Report: TAB Report
Function: Test, Adjust, & Balance
Date: 12/05/2025
Completed By: National TAB

11-03-25 WAWA #7618 LOUISVILLE, KY

Section	Page #
Summary	3
Remarks	4
Balance Schedule	9
Checklists	10
AHU/RTU	19
FAN - Exhaust	28
GRD Layout	36

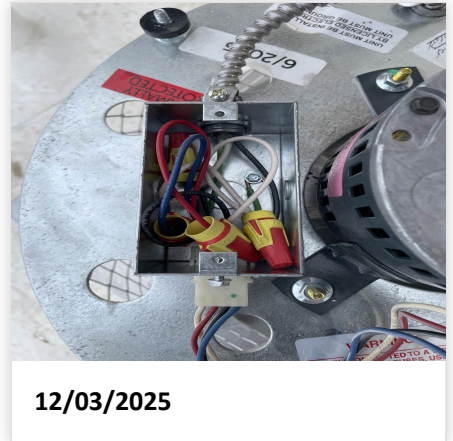
Issue Name : EF Speed Controller
Description : Neither EF-1 nor EF-2 is equipped with a speed controller as specified in EF schedule. Unable to adjust fan speeds.
Created By : National TAB **Assigned To :** National TAB - Jordan Best
Status : Open
Priority : High **Asset Tag :**
Originated Date : 12/03/2025 - Jordan Best - National TAB

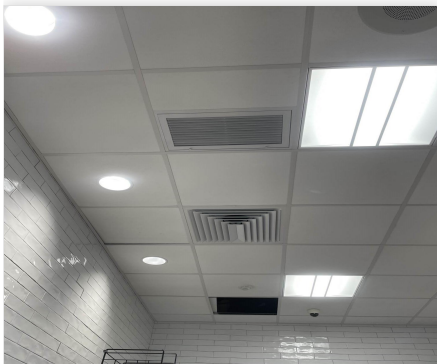
Issue Name : EF-2 Return 2
Description : RTU-2, return 2 is oriented incorrectly. Should be flush with wall above oven.
Created By : National TAB **Assigned To :** National TAB - Jordan Best
Status : Open
Priority : **Medium** **Asset Tag :**
Originated Date : 12/05/2025 - Jordan Best - National TAB
